September 22, 2015

Re: Site Specific Investigation
Soldier Springs Wellfield
Technical Review

This letter serves to present the findings of our technical review of the site specific investigation prepared by Trihydro Corporation (Trihydro) for the City of Laramie for the City owned Soldier Springs Wellfield parcel of land located within the Casper Aquifer Protection Area. Our review comments will be presented to address the adequacy of this site specific investigation in fulfilling the requirements of the City of Laramie's Unified Development Code, subsection 15.08.040.A.8.

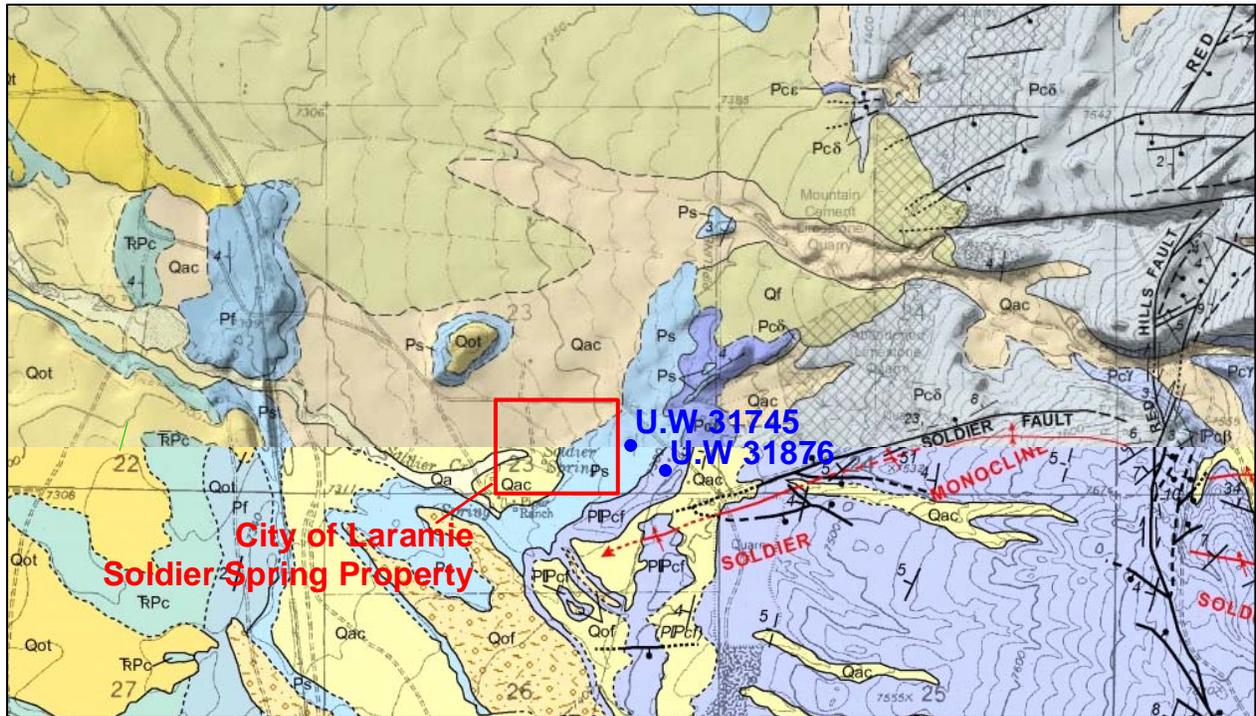
It should be noted that Figure 1 of the SSI report is incomplete. This map has been constructed by Trihydro utilizing the geologic maps prepared by Alan J. Ver Ploeg as the background (Ver Ploeg, Alan J., 2009, Revised Geologic Map of the Laramie Quadrangle, Albany County, Wyoming, Wyoming State Geological Survey, Map Series 50; and Ver Ploeg, Alan J., 2007, Geologic Map of the Red Buttes Quadrangle, Albany County, Wyoming, Wyoming State Geological Survey, Map Series 76). However, the location of the extension of the Soldier Fault and Soldier monocline from Section 23 into Section 26, of Township 15 North, Range 73 West, as portrayed on the Ver Ploeg maps, was not shown in Trihydro's Figure 1. A copy of a portion of Ver Ploeg's two maps with the City of Laramie Soldier Springs acreage called out is shown on the following page. This figure shows the extension of the Soldier Fault and Soldier monocline and their relationship to the subject property.

One item that was researched and discussed in later sections of Trihydro's SSI, but not listed in this section of their report, were the State Engineer's Office completion records for the 26 wells in the subject property area. A review of the statement of completion records for these wells reveals that "lost circulation" was encountered in two of these wells – the BK #1 well (U.W. 31745) and the Lane #1 well (U.W. 31876). Lost circulation is typically an indication of very permeable zones which in this area would be primarily from fractures and voids. The locations of these two wells are shown in the figure on the following page.

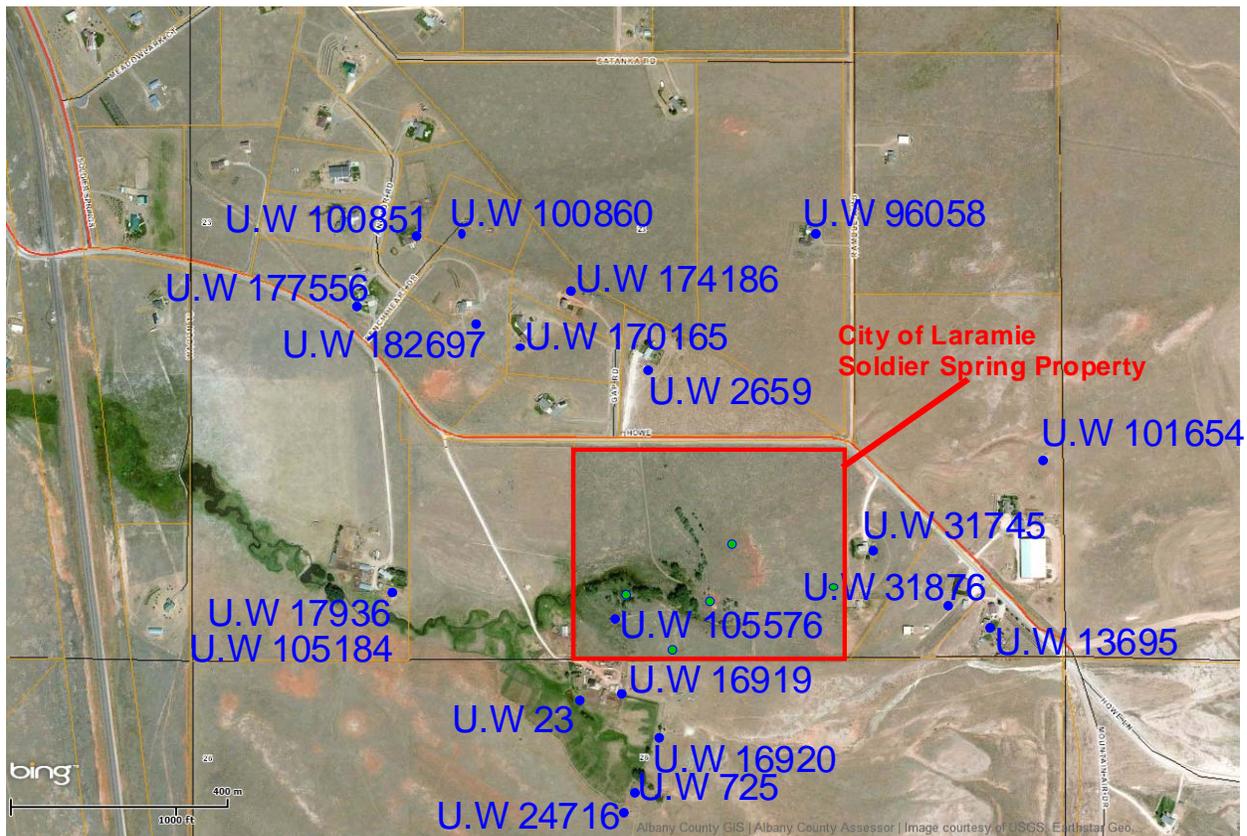
The SSI prepared by Trihydro indicates that the only planned improvements for the Soldier Springs Wellfield property is to construct a chain link security fence around the immediate wellfield facilities. The two fencing options were shown on figure 2 in the Trihydro SSI report. This figure serves as the site plan to satisfy the requirements of the City of Laramie's Unified Development Code, subsection 15.08.040.A.8. The ground contour information specified was not presented, and based on the proposed improvements is not essential information. The SSI report did present a surface geology map that has the Laramie USGS 7.5 Minute topographic map as a background (Figure 1). However, the scale of this map did not accurately reflect the topography (scale of map was too large to show adequate number of contours and the contour labeling). Contour information for the wellfield is available from the Laramie Water Management Plan, Level II Report (WWC, 2006), as shown on the bottom figure of page 2 of this letter report. The contour interval for this figure is 5 feet.

In general we agree with the concept presented in the SSI report that the information provided is adequate to demonstrate the proposed development plans for this parcel of land. However, we feel it would be beneficial to the City to include some of the requested information such as a topographic map, a discussion of the existing land use practices in the area and some general discussion with respect to development constraints or issues associated with this parcel of land due to its proximity to the vulnerable features identified in paragraph 15.08.040.A.8(d)(i).

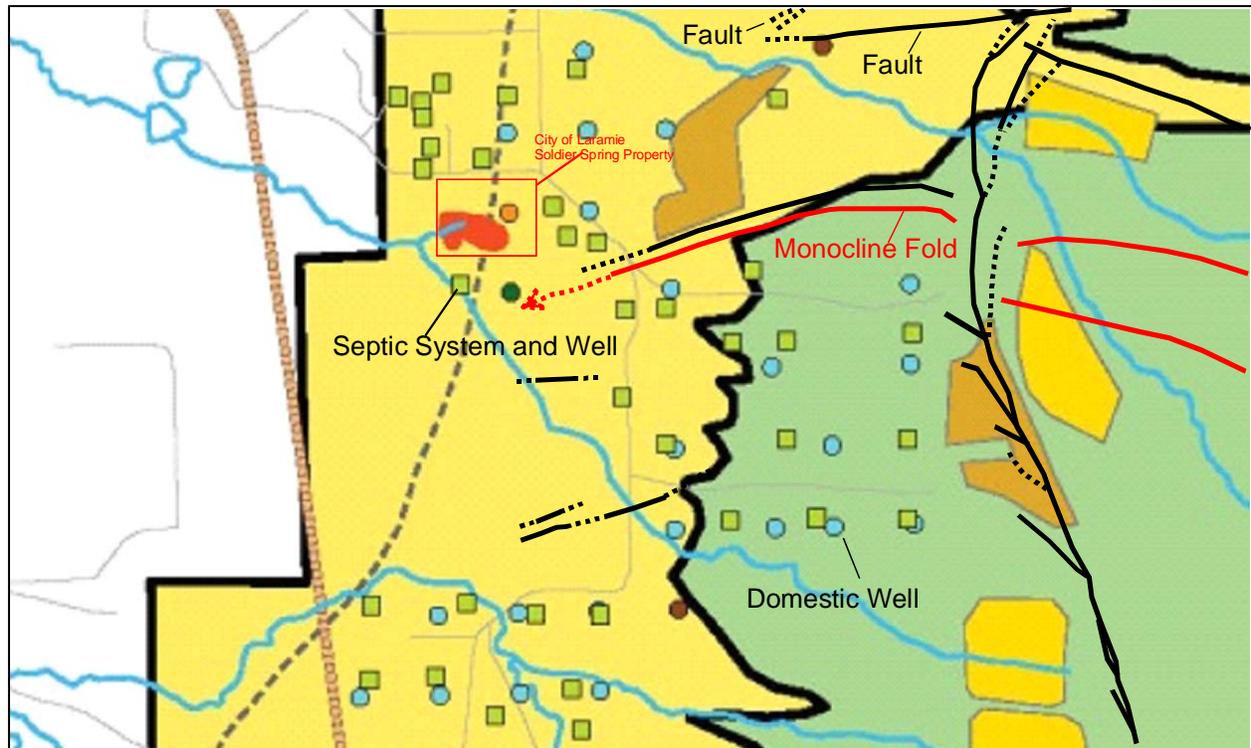
The figure on the following page is a portion of Figure 4-2a from the Casper Aquifer Protection Plan (Wittman, 2008) which shows the locations of the wells and septic systems in the area of Soldier Springs Property. The Casper Aquifer Protection Plan identifies twenty (20) septic systems that are cross-gradient or up-gradient from Soldier Springs. Superimposed upon this figure are the geologic structures (faults and monocline folds) in the area from the Ver Ploeg mapping (2007 and 2009). This figure shows that most of these septic systems and wells are

located in an area that has not been structurally disturbed which will minimize the potential for conduit flow and the rapid movement of potential contaminants through the aquifer.

1. Review the wells and septic systems in the area where conduit flow between these systems and the Soldier Springs wellfield is very likely. A review of the figure on page 5 of this SSI Review letter indicates that there may be as many as 6 septic systems and several wells that are in potential conduit flow areas.
